GENTEMANN MANOR

SITE LAYOUT

SITE PLAN

GENTEMANN MANOR III

SHEET NO.
C1.0

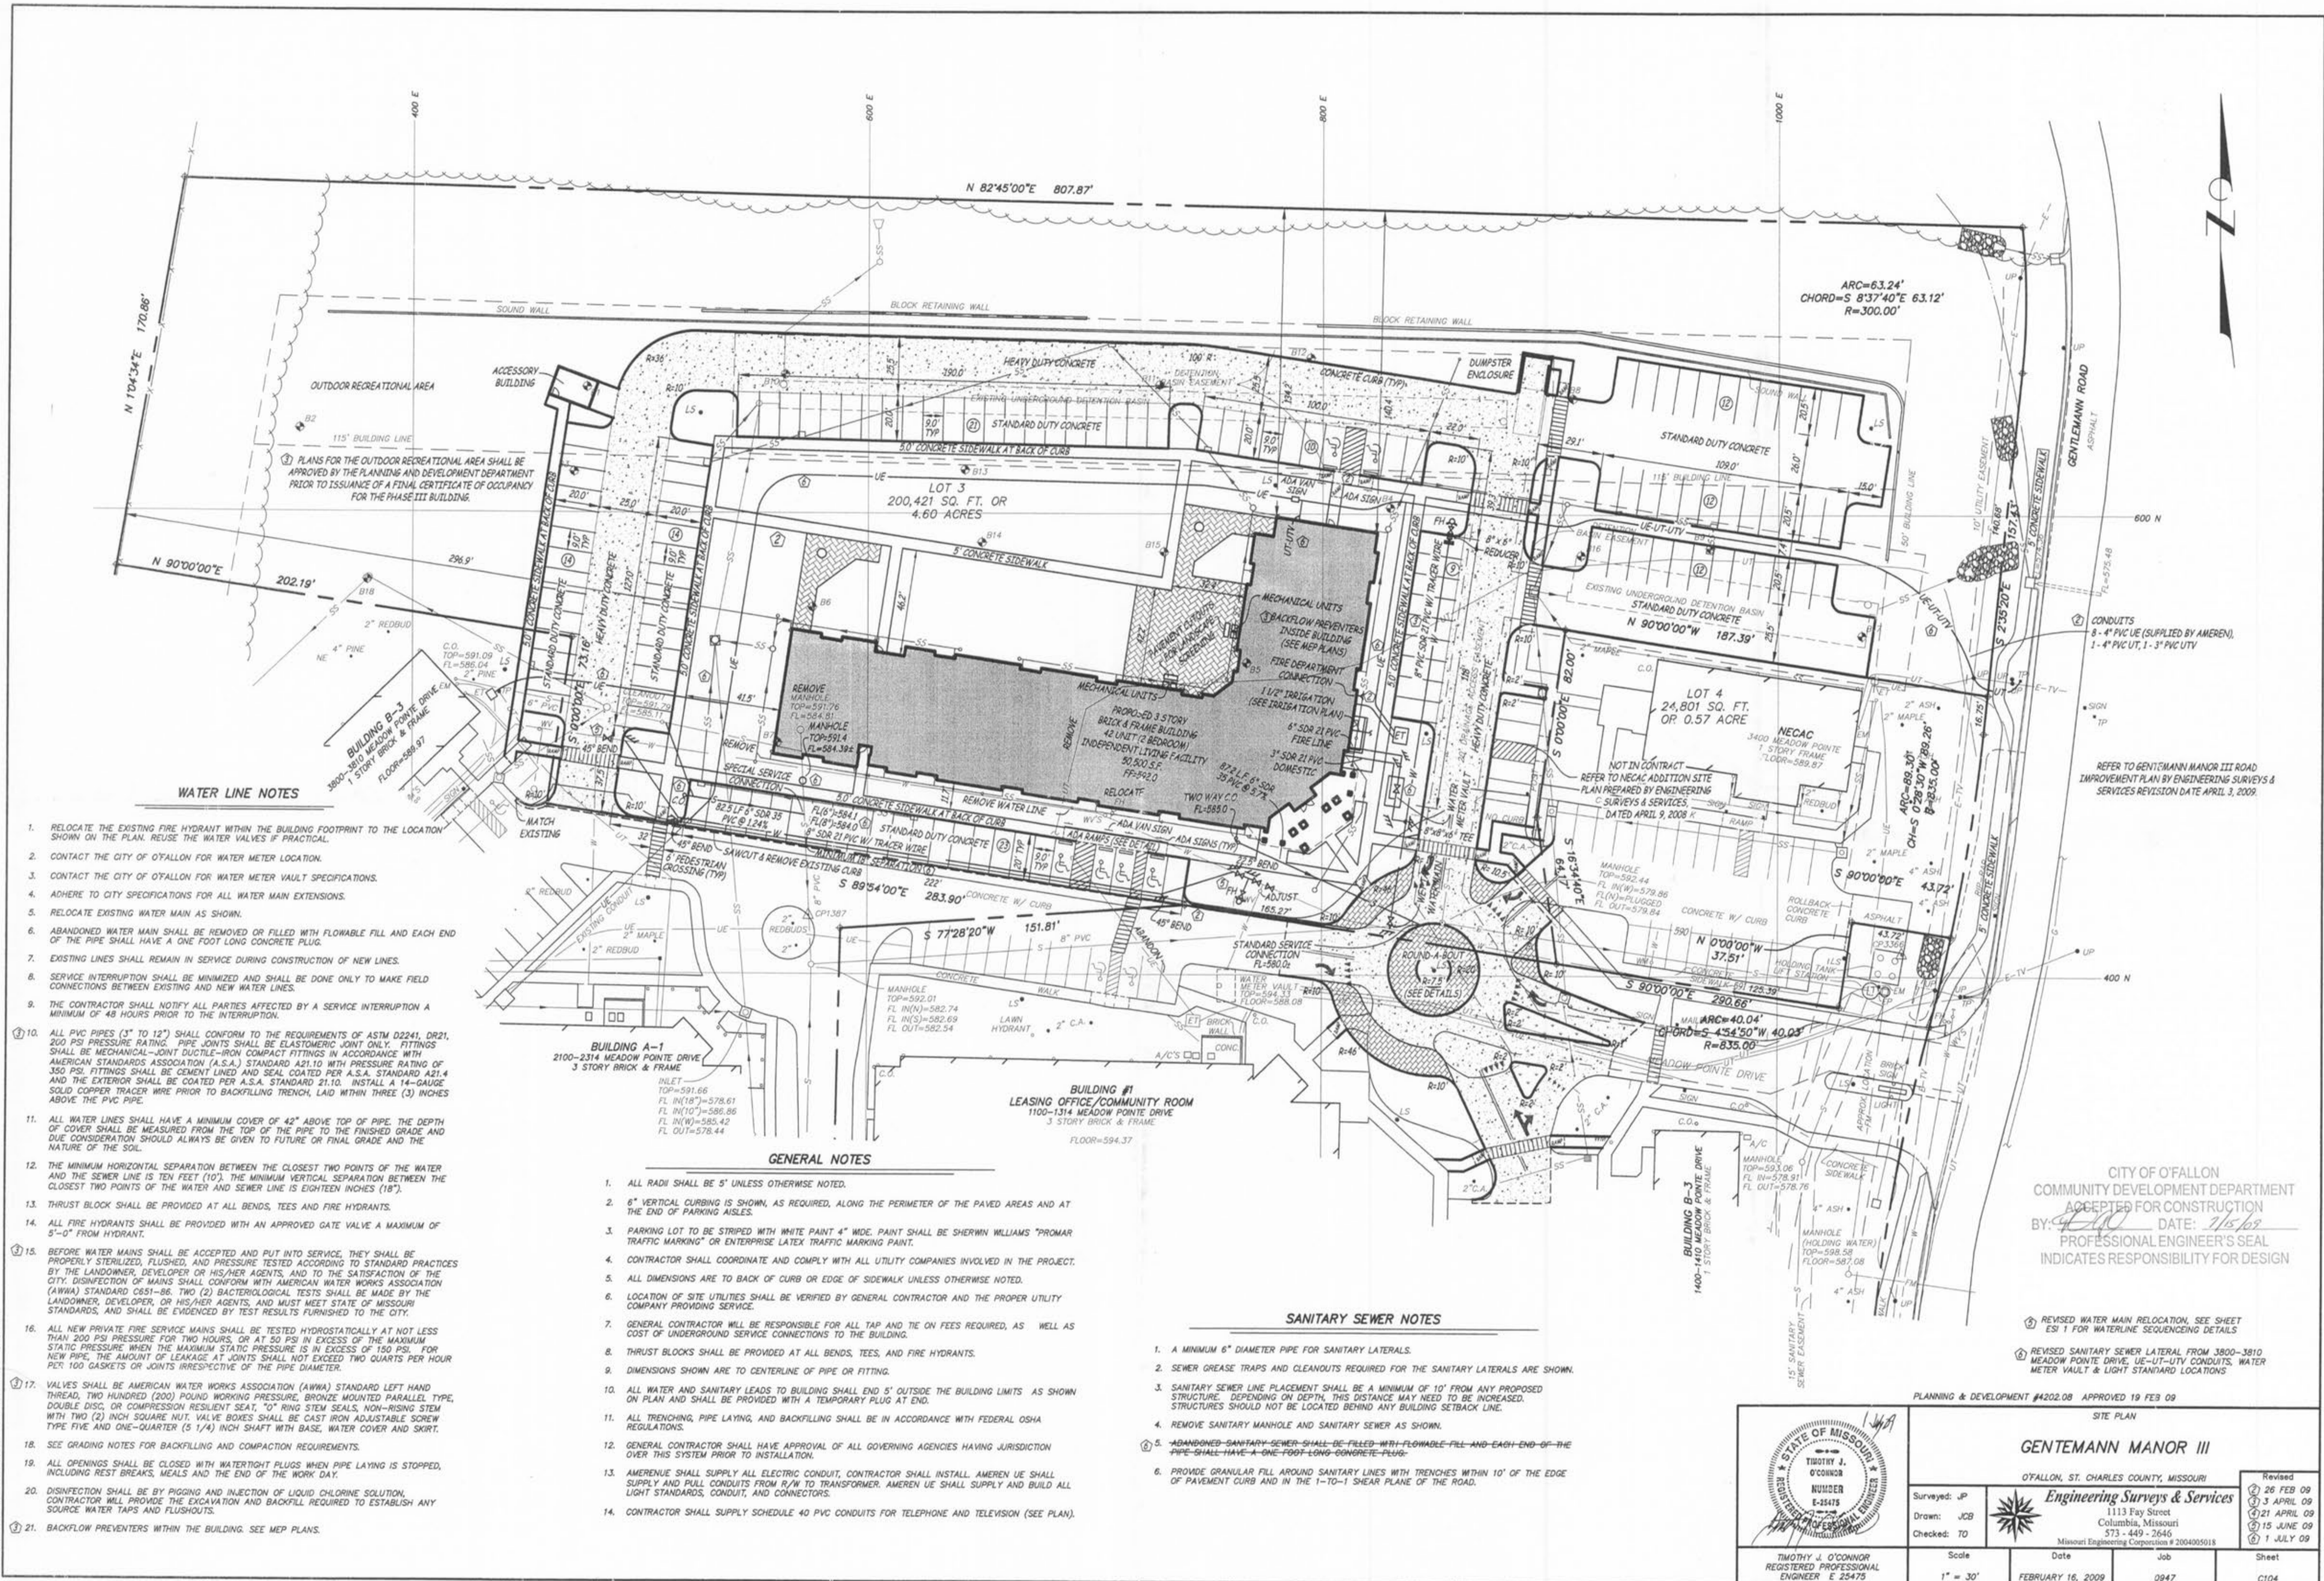
REVISED WATER MAIN RELOCATION. SEE SHEET
 ES1 FOR WATERLINE SEQUENCING DETAILS
 REVISED SANITARY SEWER LATERAL FROM 3800-3810
 MEADOW POINTE DRIVE, UE-UT-UTY CONDUITS, WATER
 METER VAULT & LIGHT STANDARD LOCATIONS
